Certificate of Appropriateness

2212 E. KENILWORTH PL.

North Point South Historic District

PTS ID 101732 COA

1 ALTERNATE PROPOSED REAR/NORTH ELEVATION
A2 Scale: 3/16" = 1'-0"

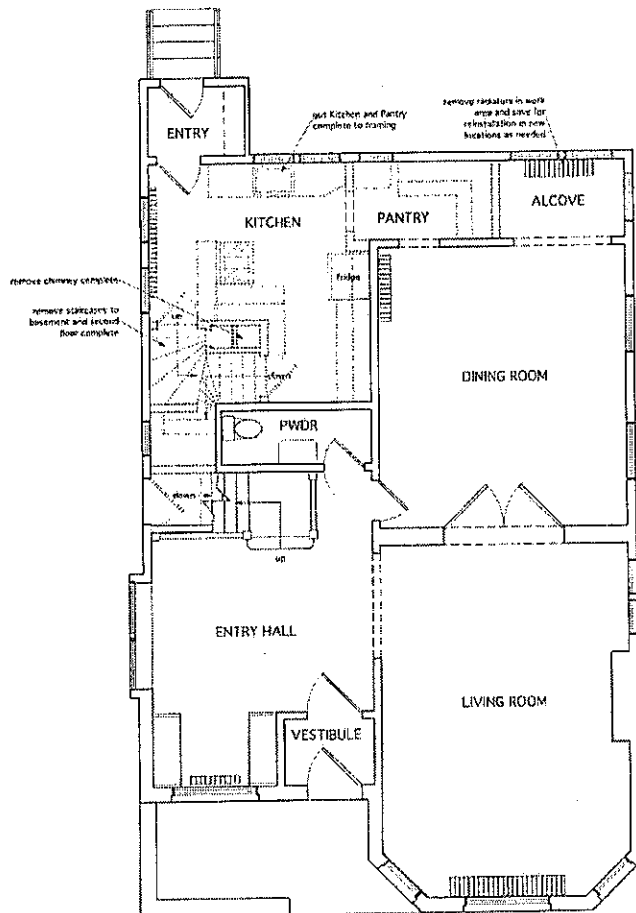
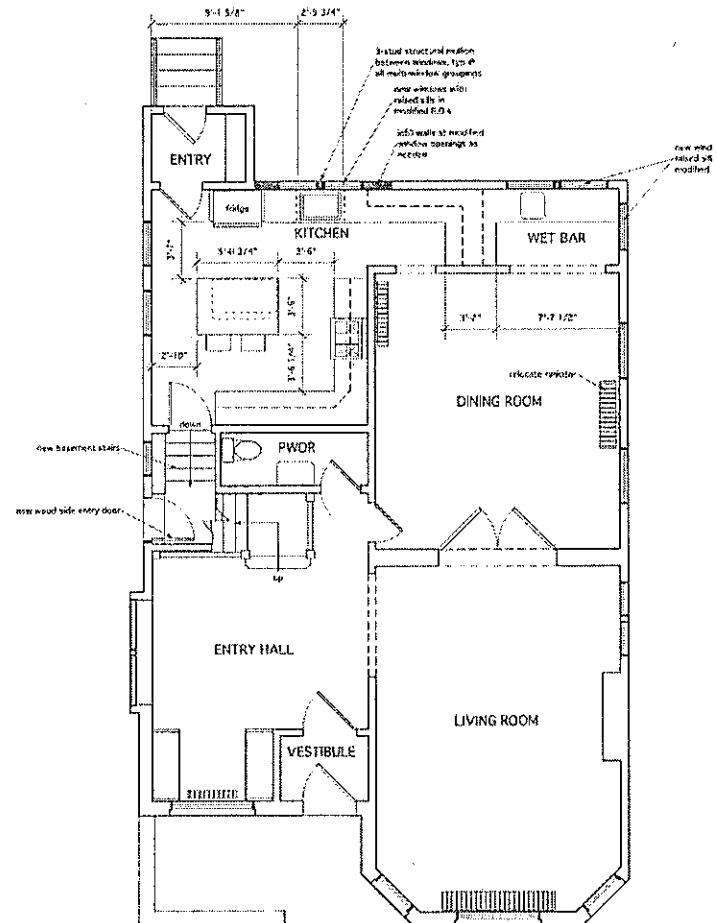
Alternative solution to shortening windows is acceptable. It preserves potential for re-installing larger windows in future. If selected, the panels must be of wood and painted to match the house.

Windows may be raised/shortened as shown in the attached drawings. If the exterior frame is retained as shown in the alternative proposal, the infill must be of wood and painted to match the rear clapboards. If the exterior frame is shortened, wood clapboards to fill in must match the existing in size, thickness and wood species.

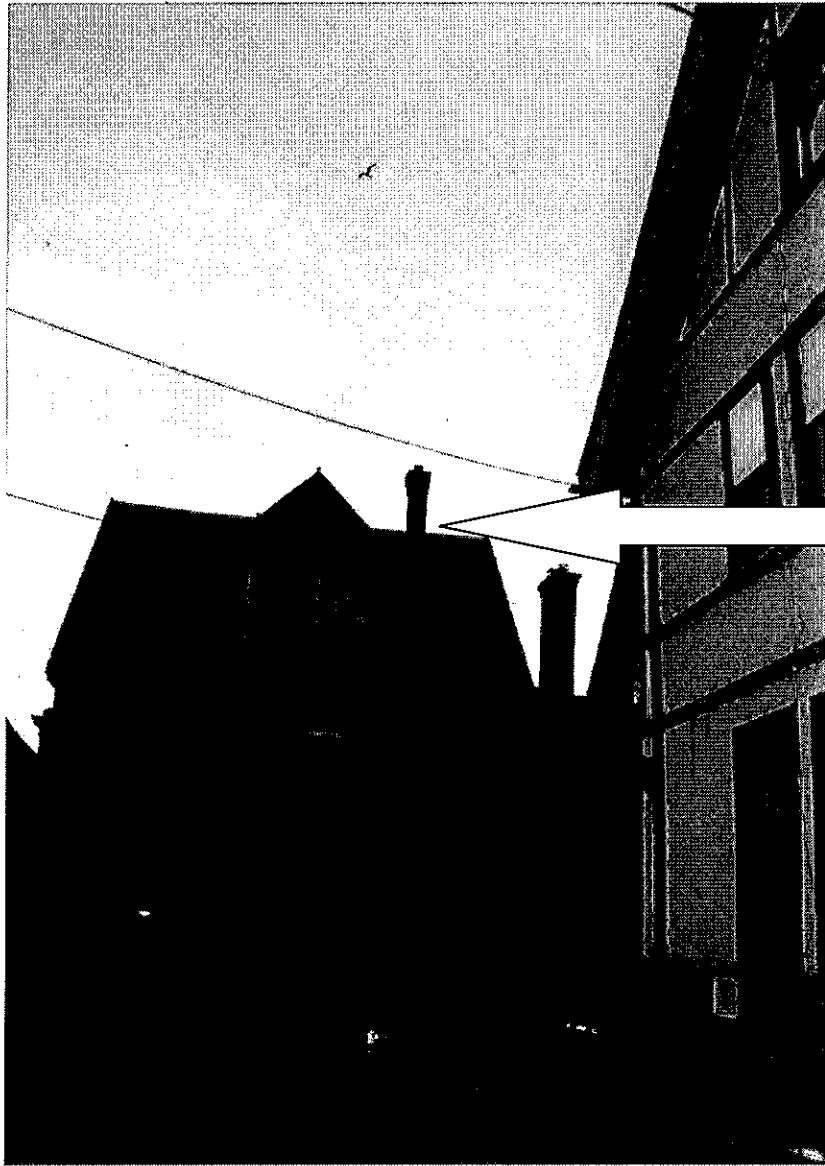
Rear concrete stoop to be replaced. New wood doors should match existing as in photograph or resemble images from period catalogue at right. Another alternative would be to properly weather strip prime door and install a new wood full view storm door.

Rear chimney will be removed
